Addendum #01

Date: June 25, 2021

Project: Huntington Middle School Modernization and Addition

DWG. #: **ADC-001**
JOB #: 21938.00
DRAWN BY: PVR
DATE: 06/25/21
REF. DOC.: ADDENDUM 01

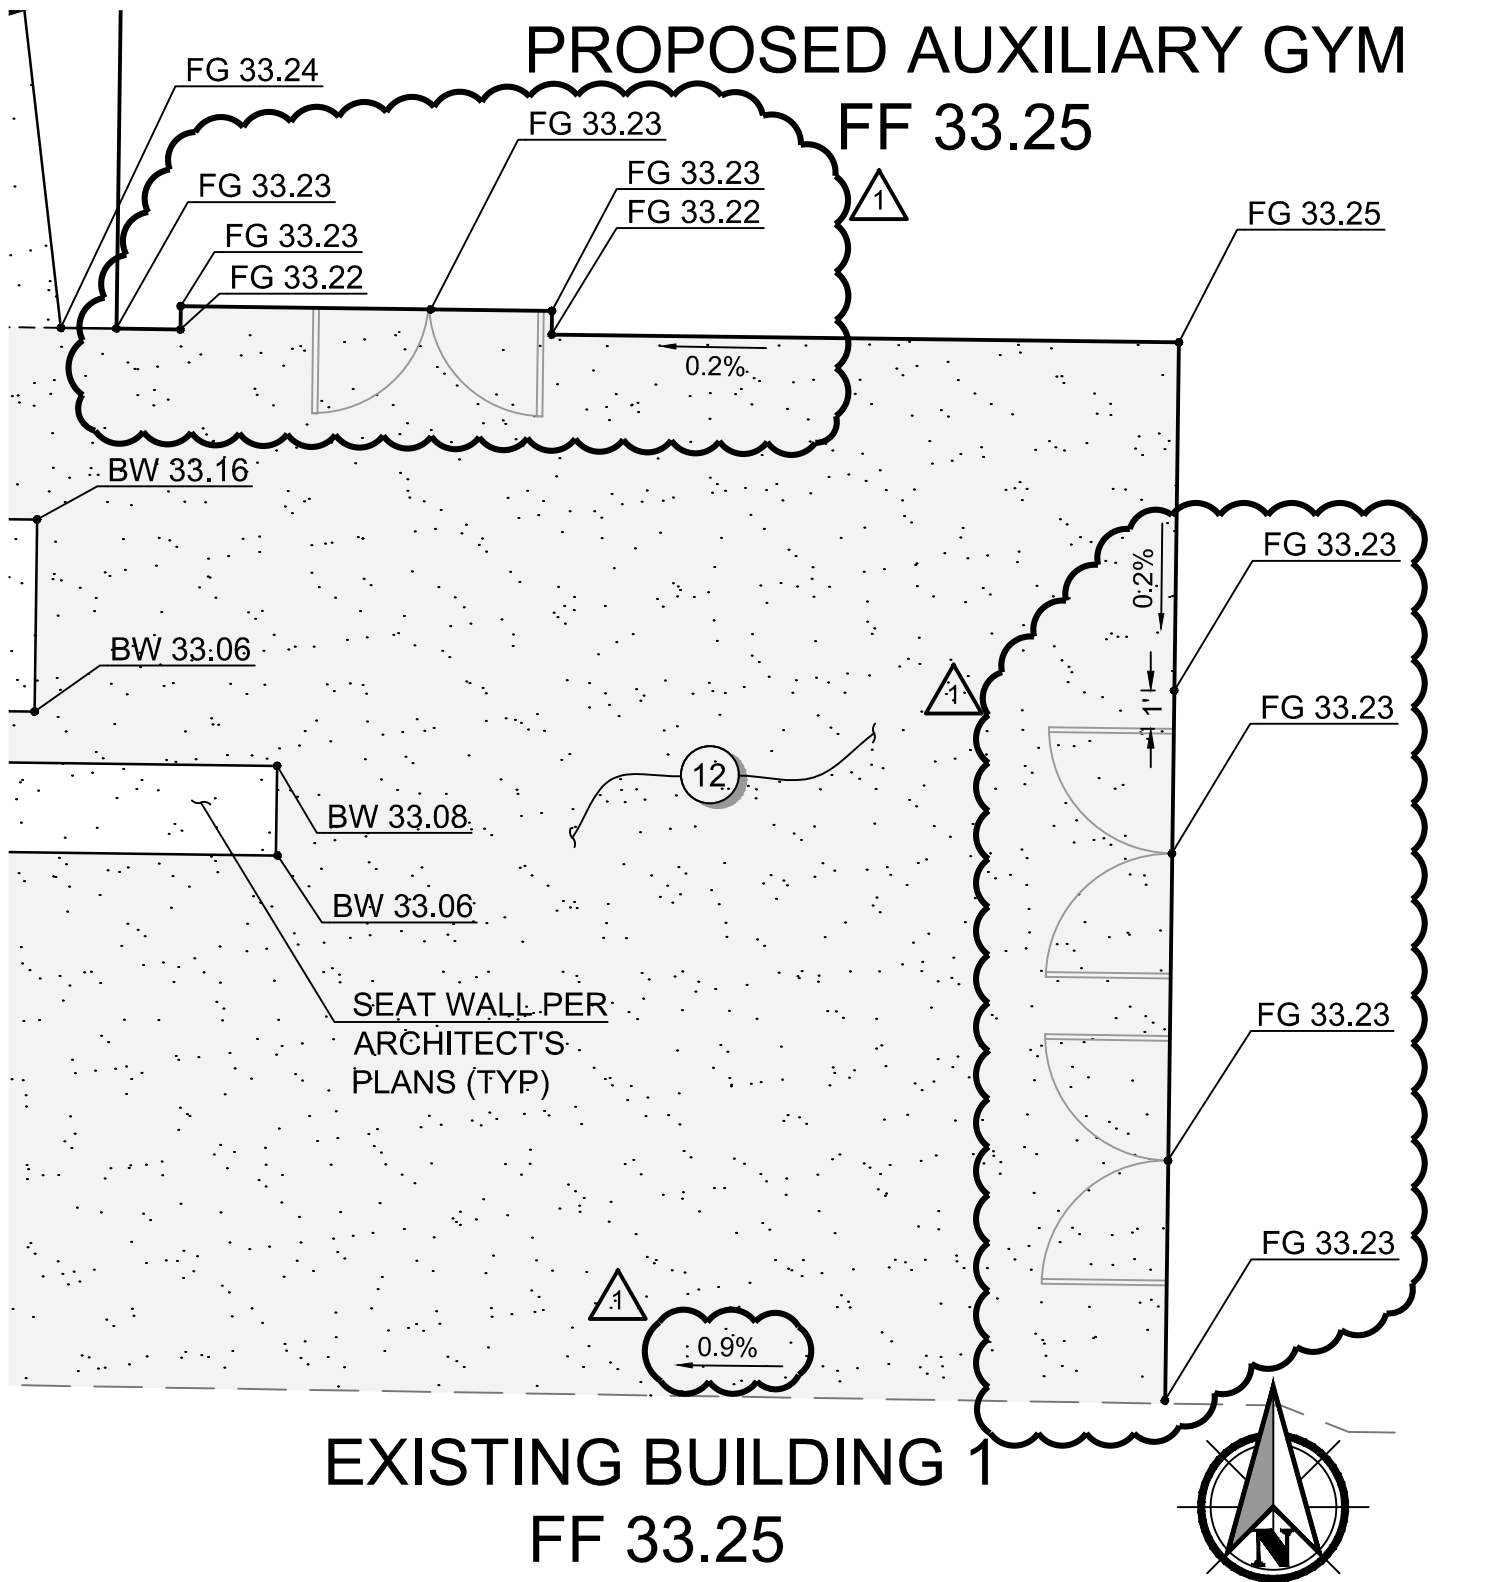
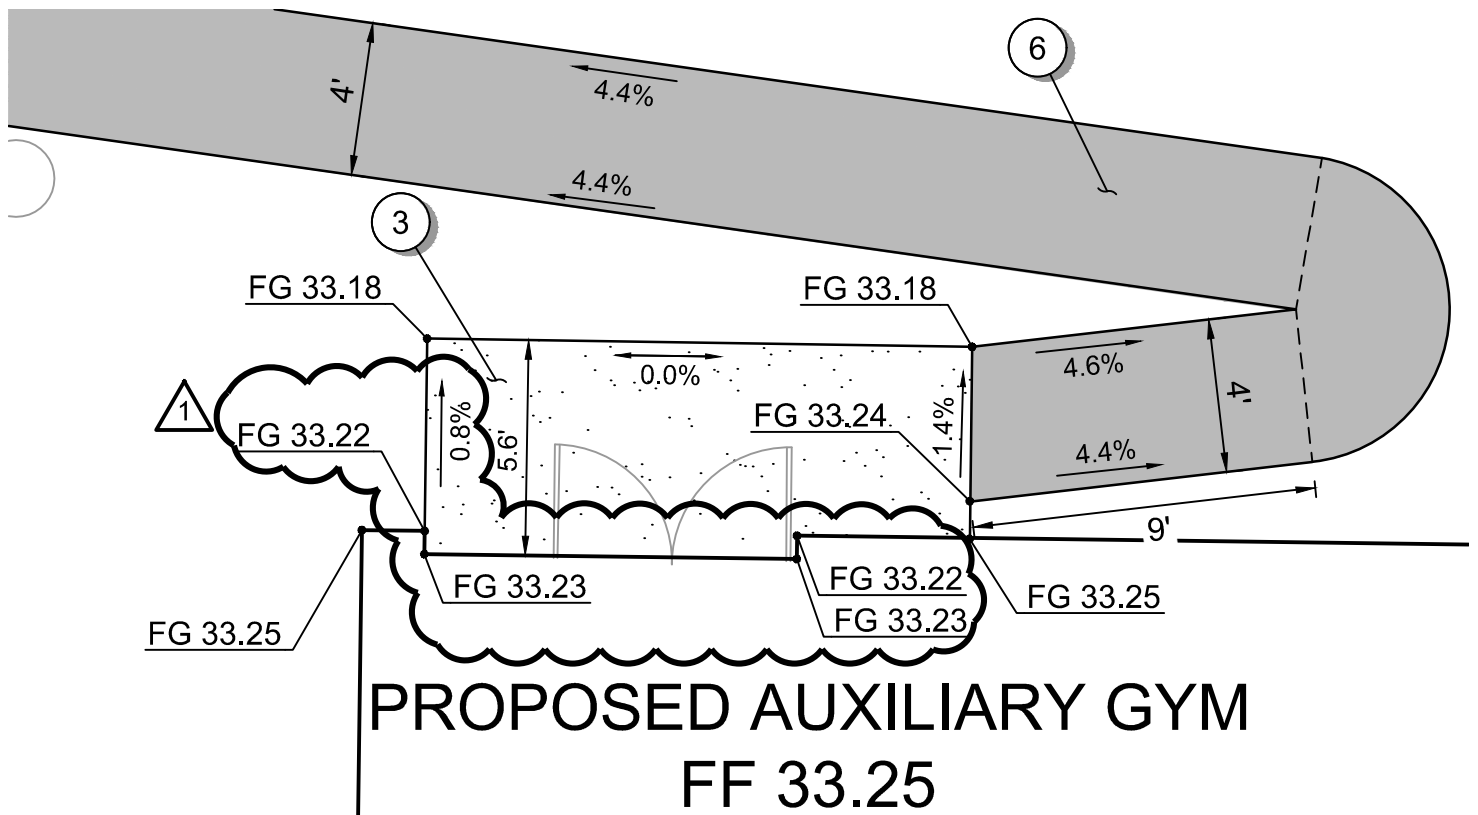
Item #C01 C403 - Auxiliary Gym Grading Details
Add. #01 Revise sheet C403 per attached **ADC-001**

C402

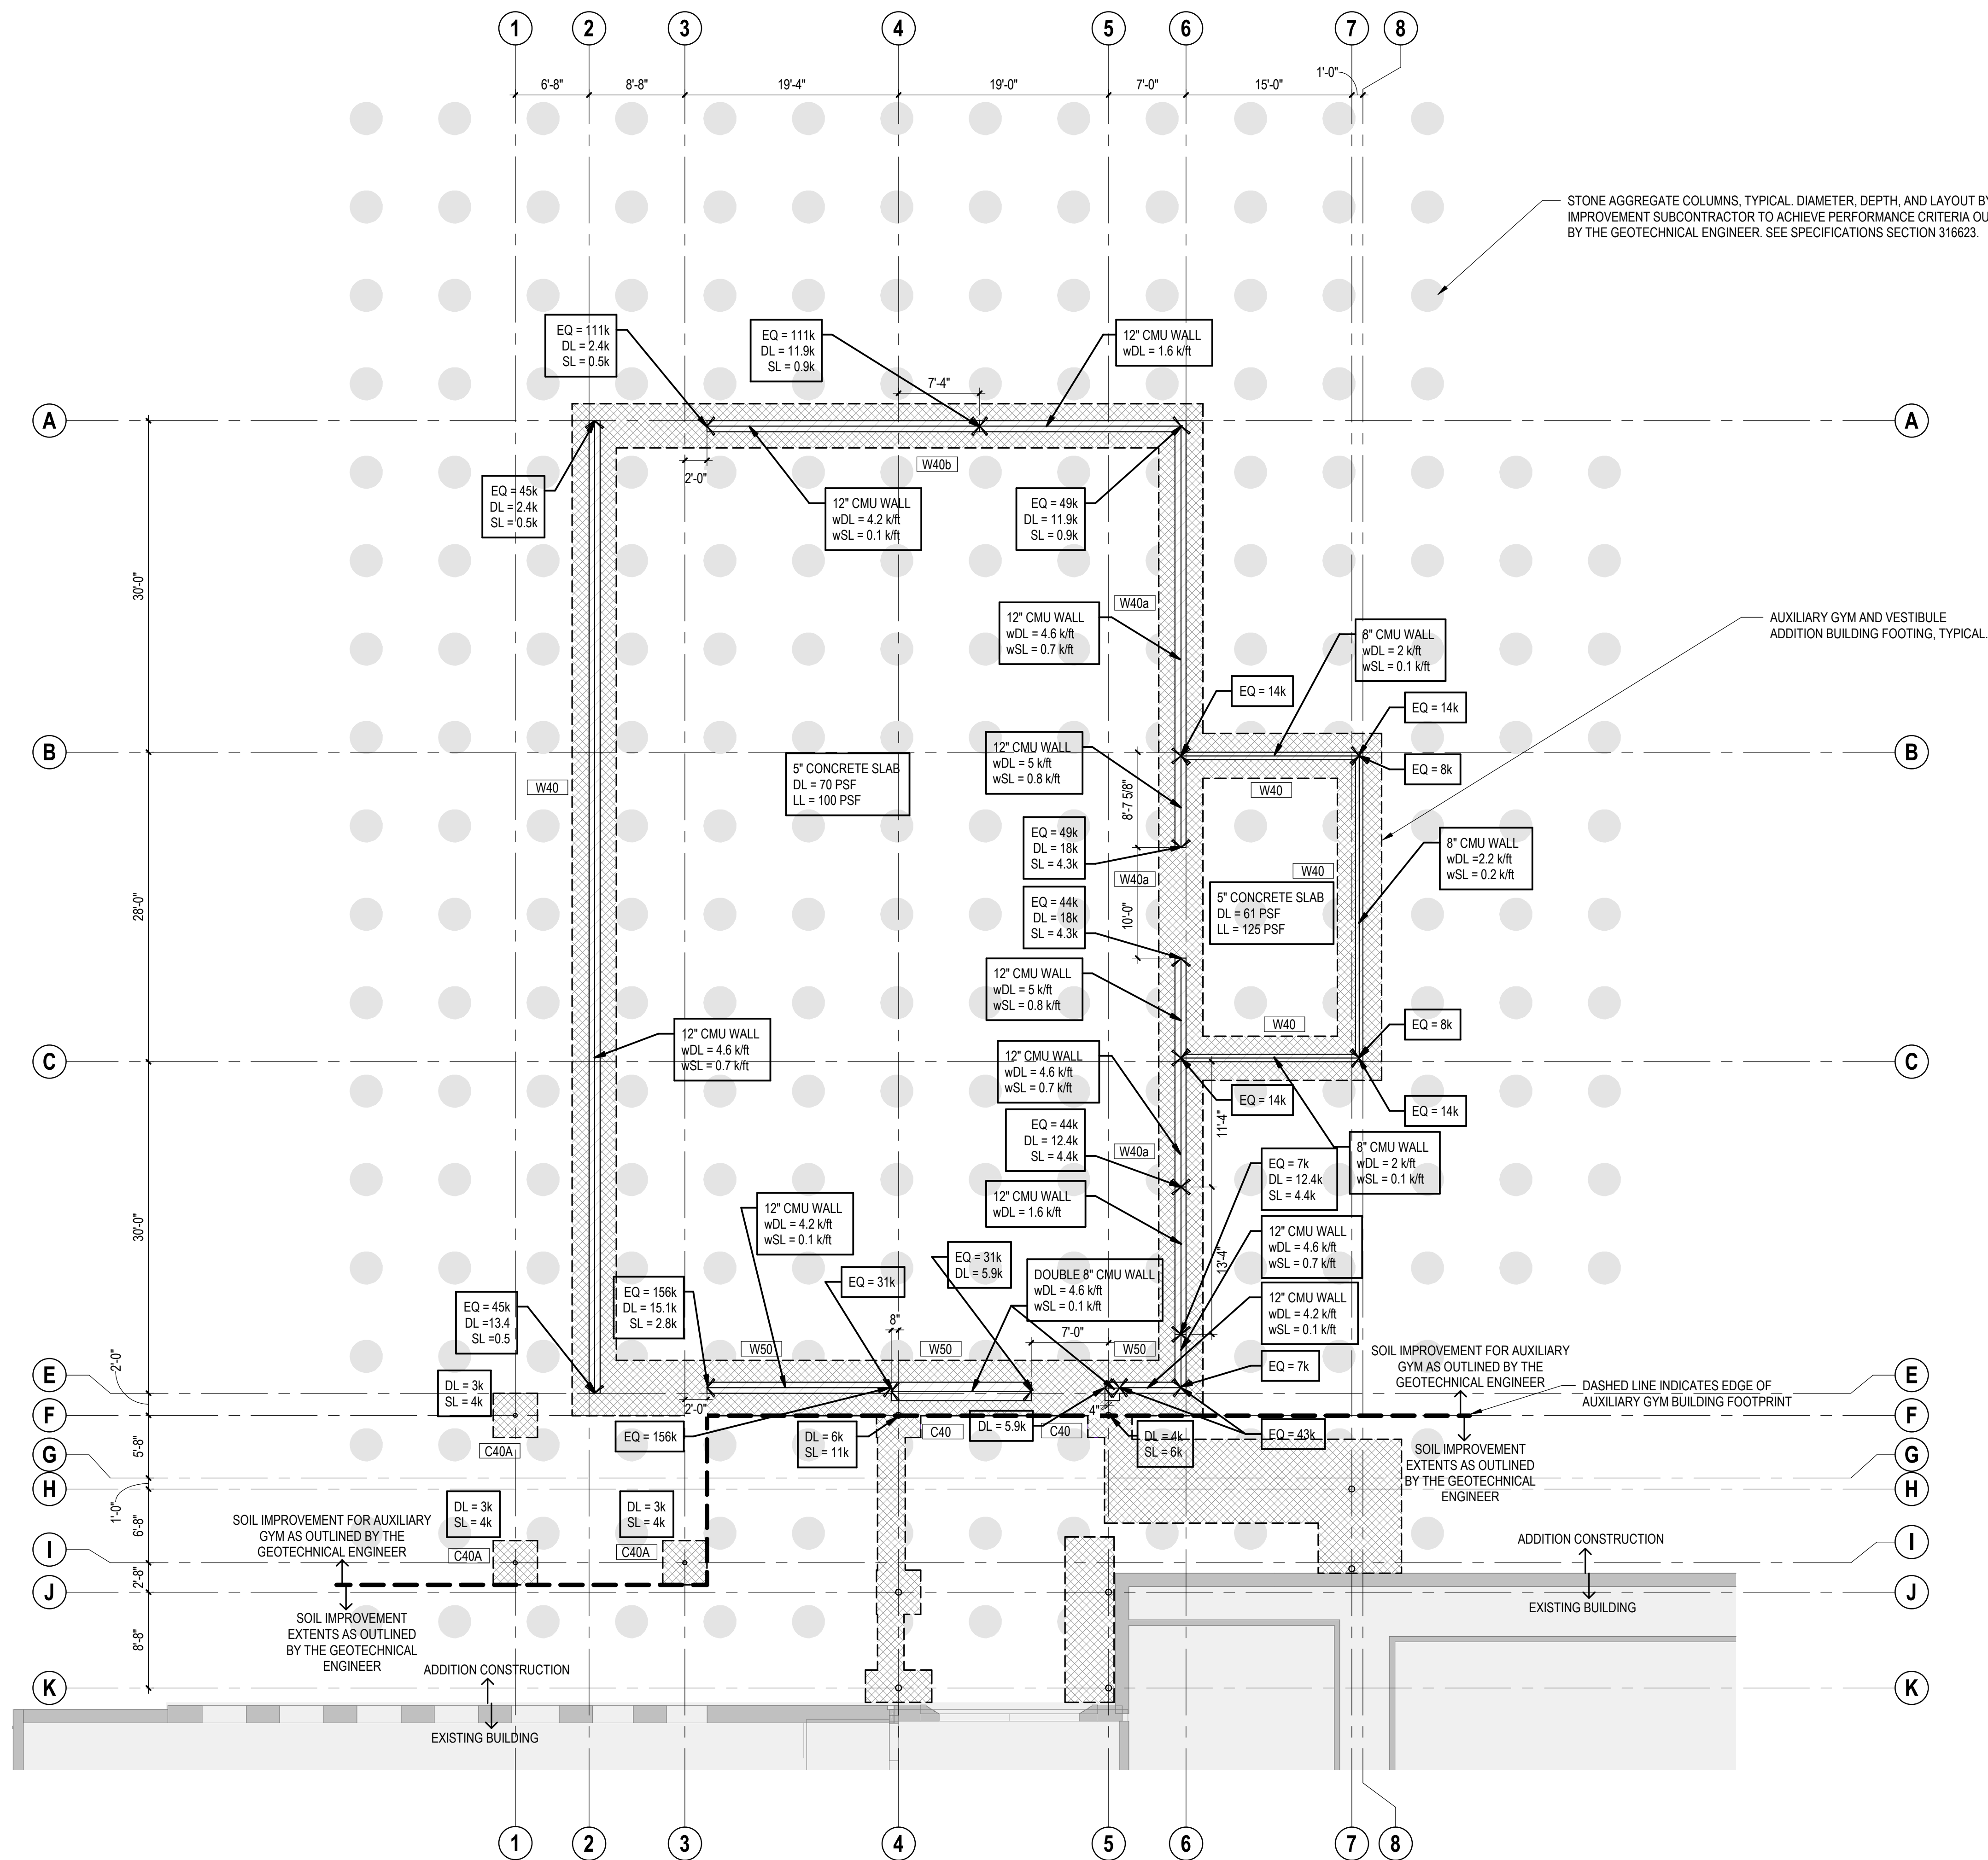
Item #C02 C402 - Auxiliary Gym Grading Details
Add. #01 Revise sheet C402 per attached **ADC-002**

SOIL
IMPROVEMENT
PLAN - ADDITION
AREA C -
AUXILIARY GYM

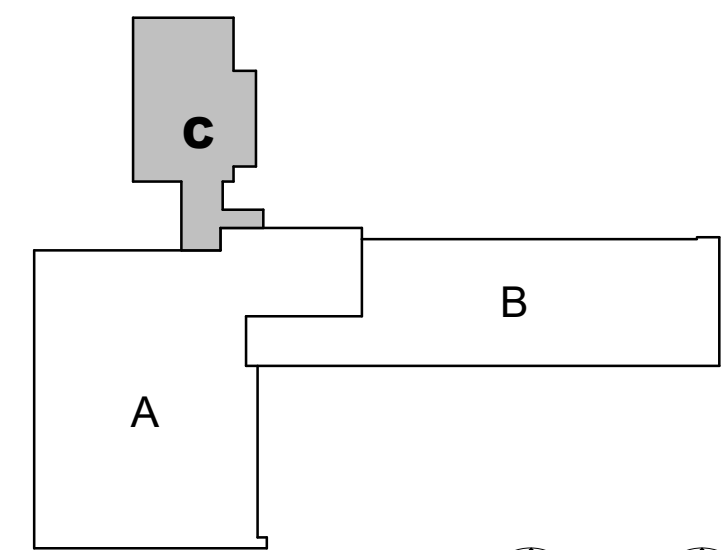
Item #S01 S100.0C – SOIL IMPROVEMENT PLAN – ADDITION AREA C -AUXILIARY GYM
Add. #01 **Replace** sheet S100.0C per attached sheet **S100.0C**.

INSULATED GLAZING PANELS

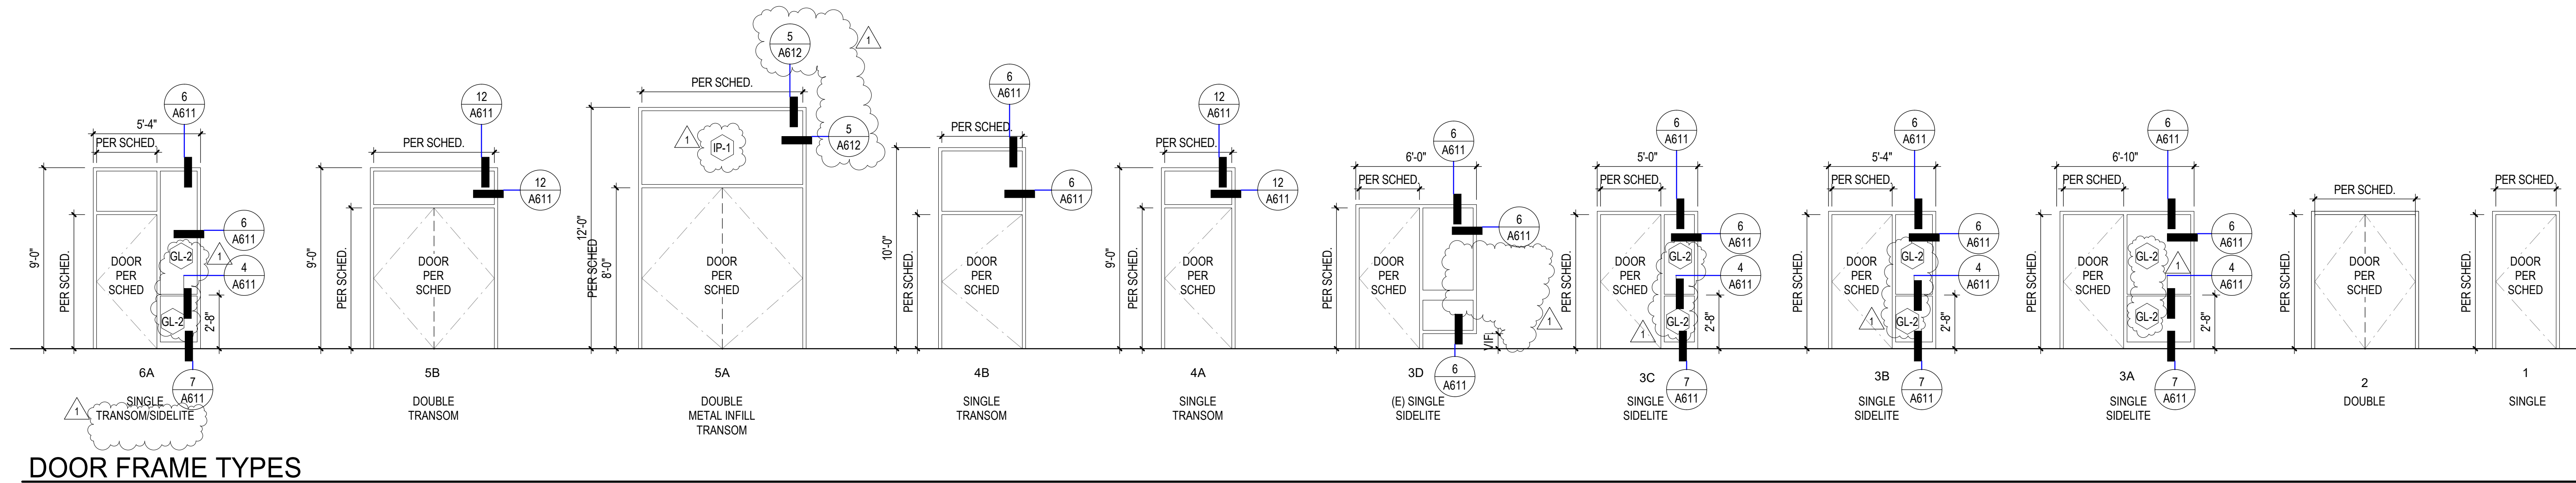
Add: Paragraph 2.10
2.10 INSULATED GLAZING PANEL (IP-1)
A. Basis of Design: Thermolite (EPS):
1. Thickness: 1 inch.
2. R-Value: R-3.3 (ASTM C518).
3. Core: 2 pcf density polystyrene.
4. Stabilizers: Extruded corrugated polypropylene.
5. Sheet: ASTM B209:
a. Face Thickness: 0.015 inch nominal or thicker.
b. Backer Thickness: 0.0125 inch nominal or thicker.
6. Fire Performance (ASTM E84 Class A)
a. Flame Spread Index: not more than 25.
b. Smoke Developed Index: not more than 450.
7. Substrate: Hollow Metal Frames.
8. Finish: Kynar/Hylar.
9. Color: To match P-2.”
